**Resource Consent Application 67958
Kaituna River Re-diversion and Ongatoro/Maketu Estuary Enhancement
Response to further information request**

We write in response to the request for further information dated 14 August 2014 relating to the Regional Council resource consent applications for the above. We have had feedback from each of the relevant technical experts on the points raised and respond to the request in the attached table.

Photo 1 Example of log deflector

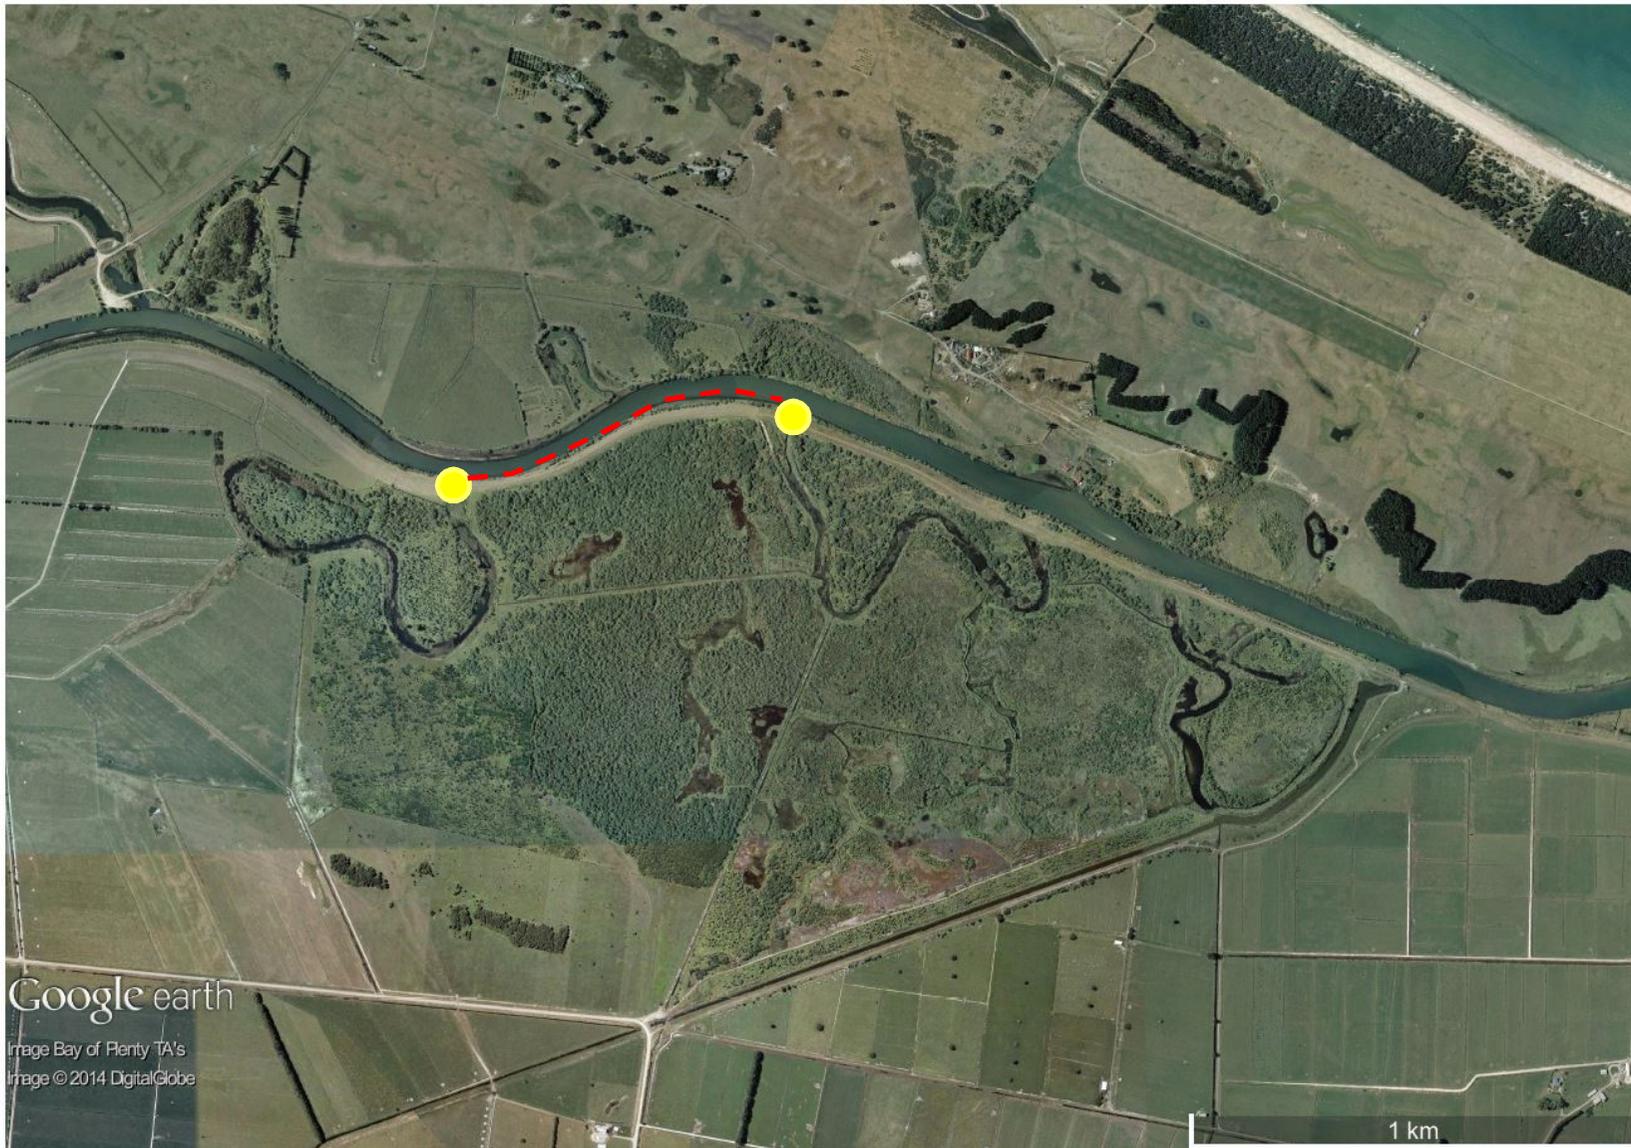
<p>4. Log Deflector Information requested:</p> <p>(i) As a minimum, please provide some details of the proposed design and construction of the proposed 'log deflector'. Please note that these do not have to be final and the purpose would be to enable Council to set some parameters around a 'final' plan for later certification by Council (should resource consent be granted).</p>	<p>The log deflector is shown on drawing sheets 2 and 16 (extract below). It is a structure designed to prevent debris in the river entering the backwater created by the proposed 'Corbett Fill No 2'. The fill is proposed to end as shown on the drawing so that the existing users of the river launching area (Boy Corbett, Motiti Barge Operator) can continue to use this location. The log deflector needs to let water into the embayment but prevent debris (floating and submerged logs and weed mats) from doing so. It is proposed that it be constructed in a similar fashion to that shown on Photo 1, i.e. driven wooden piles with horizontal rails. The vertical height of the structure will be designed to prevent debris entry between low tide and flood levels. Using driven piles will reduce the construction effects.</p> <p>The exact detail will be finalised during detailed design.</p>
